**STAFF COMMENTS:**

JOB NO. 2319  
DATE: 10/13/2023  
Development Plan

Z100

**1 Development Plan**  
1" = 20'-0"

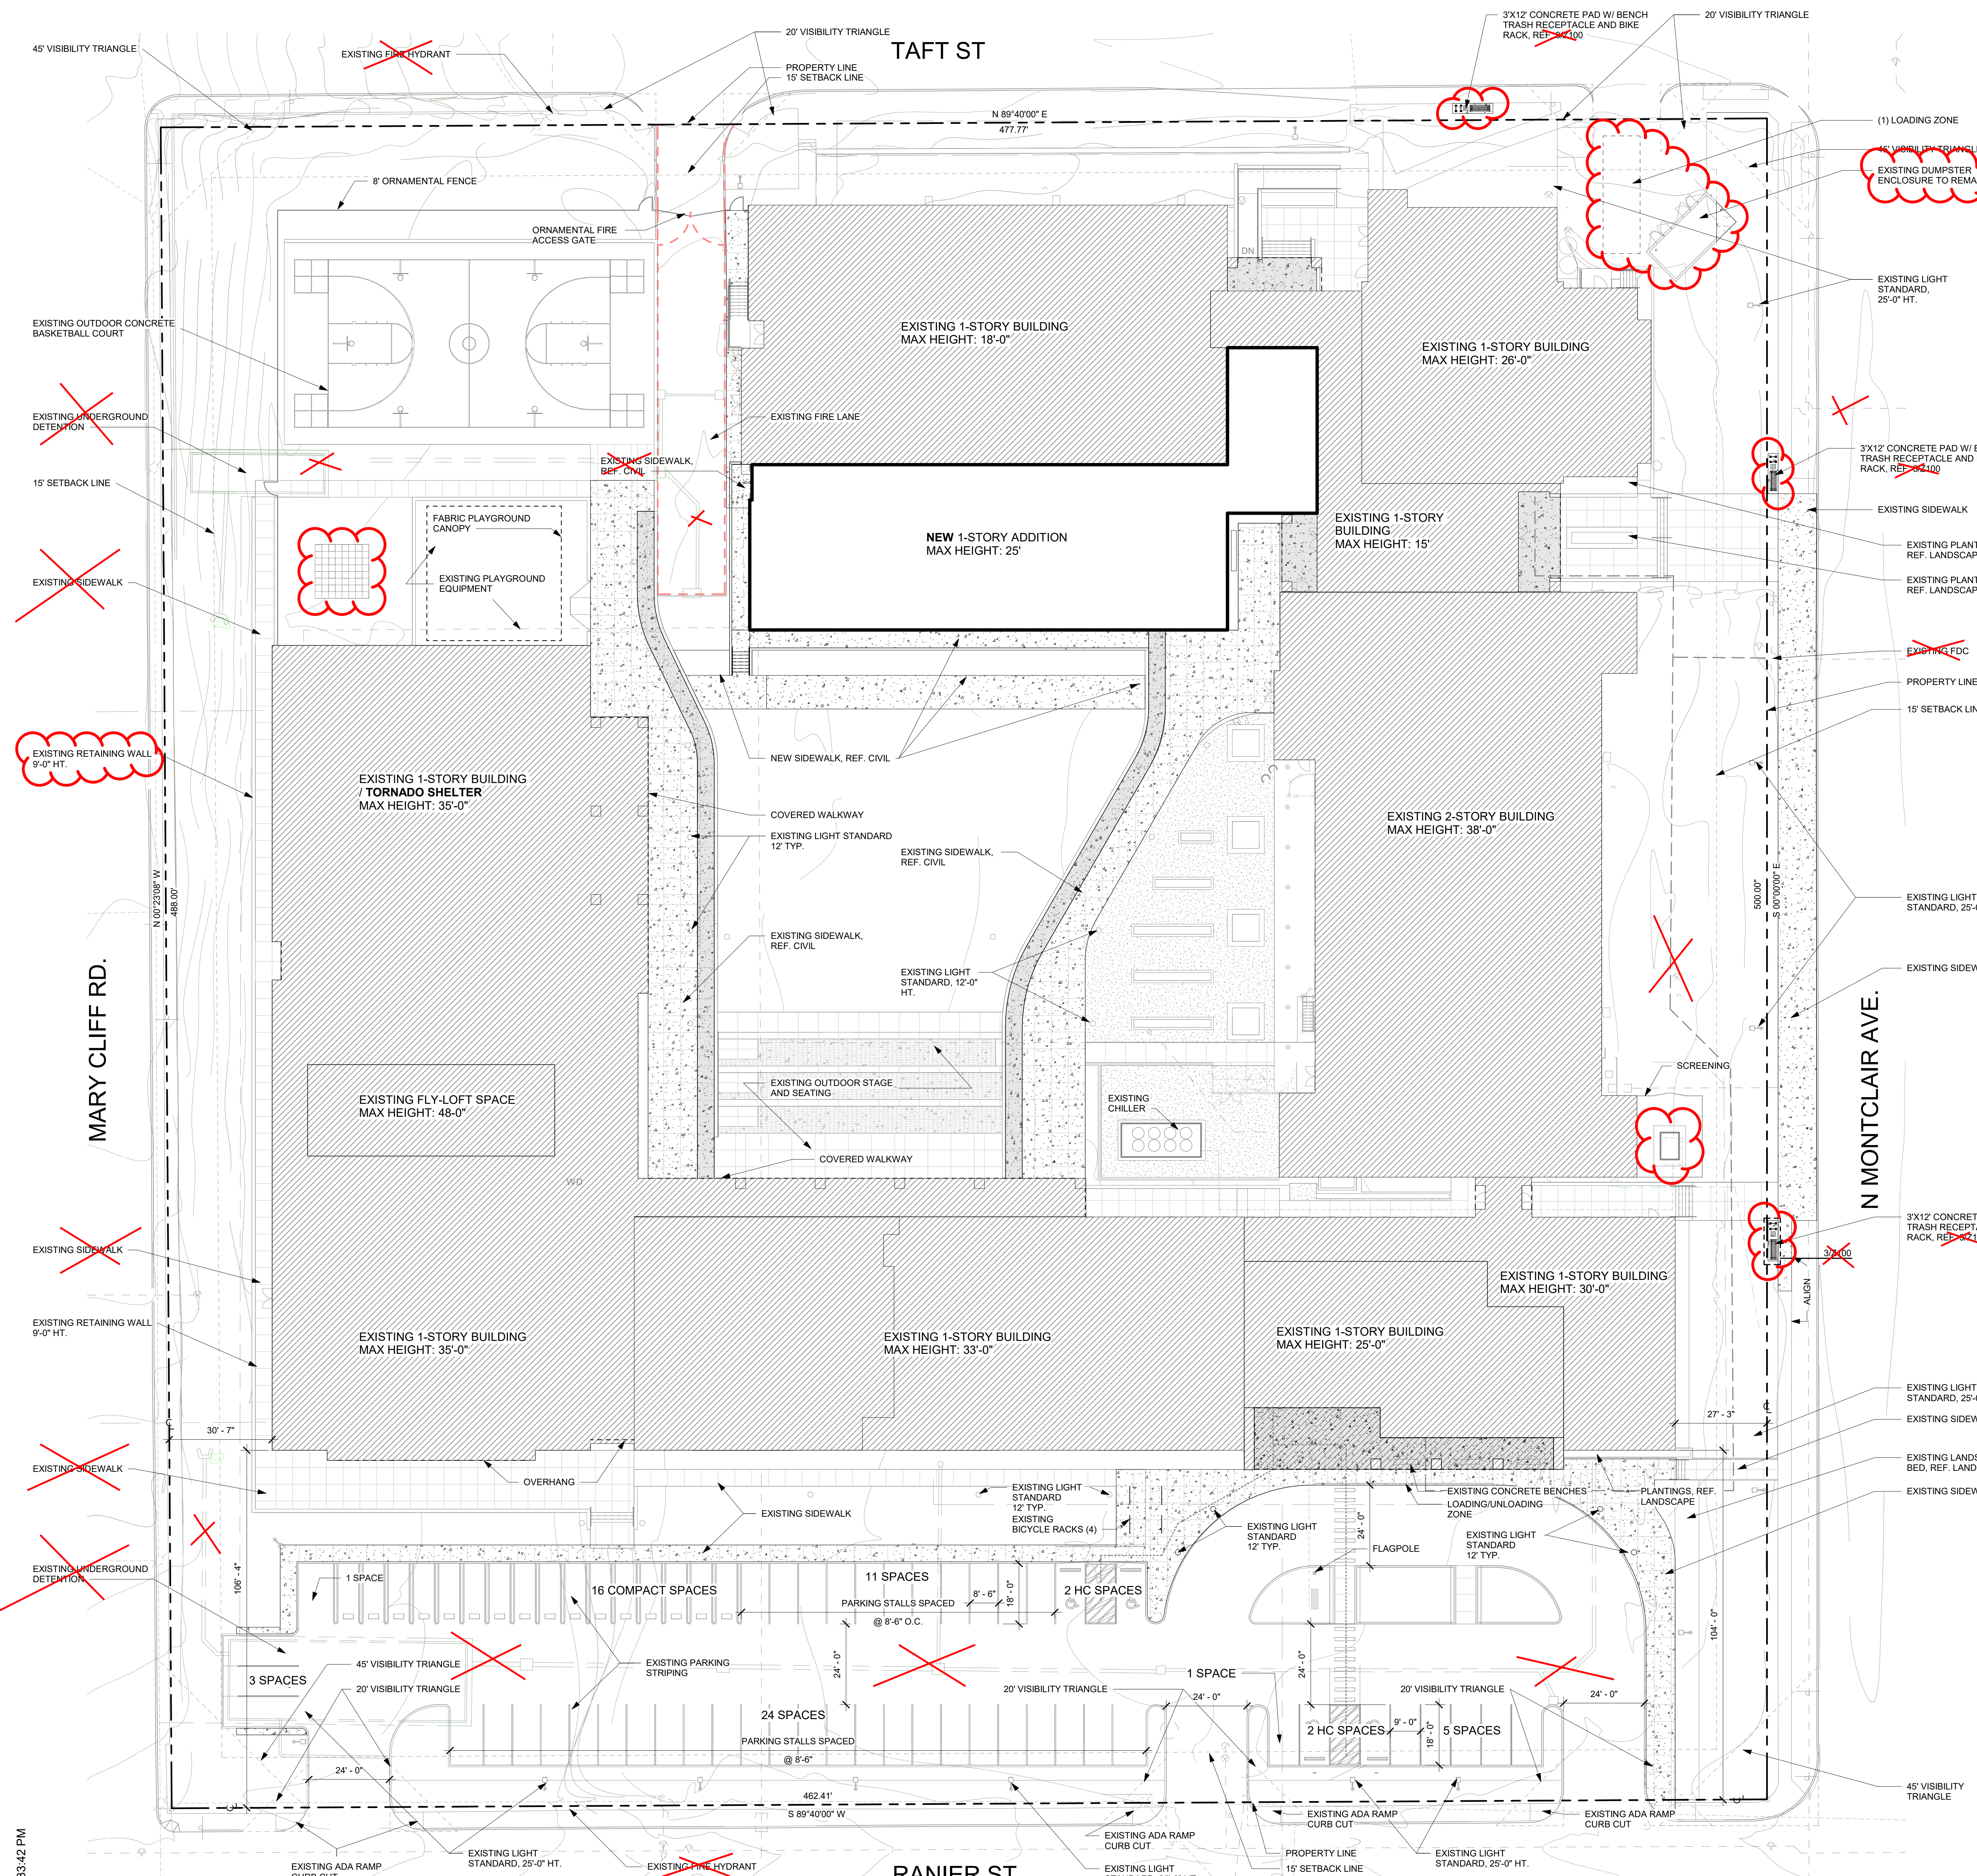
- 1. Plan clean-up:**
  - > show location of amenities but remove detail from plan
  - > show correct location of retaining wall along mary cliff
  - > remove stray/unidentified shapes/marking, including any underground utility information (where are easements tho?)
  - > identify public sidewalks/buffer to remain; show 6' foot sidewalk w 5' buffer at locations to be upgraded
  - > remove underground detention infrastructure from plan
  - > dash in existing storage building at Taft and add call out w note that it is to be removed
  - > do not show hydrant locations on dev plan
  - > topo lines need elevation identifiers
  - > dimensions of loading space?

- 2. Update data tables:**
  - > parking required needs to be a whole number
  - > indicate number of loading spaces required
  - > indicate number of bicycle parking spaces required and add note that location to be determined at permitting
  - > net lot area?
  - > confirm all data per conditions

- 3. Recommended changes:**
  - > relocate dumpster or reorient so not facing surrounding residential
  - > provide additional pedestrian amenity areas at perimeter and/or at strategic locations more internal to the property
  - > additional sidewalk upgrades
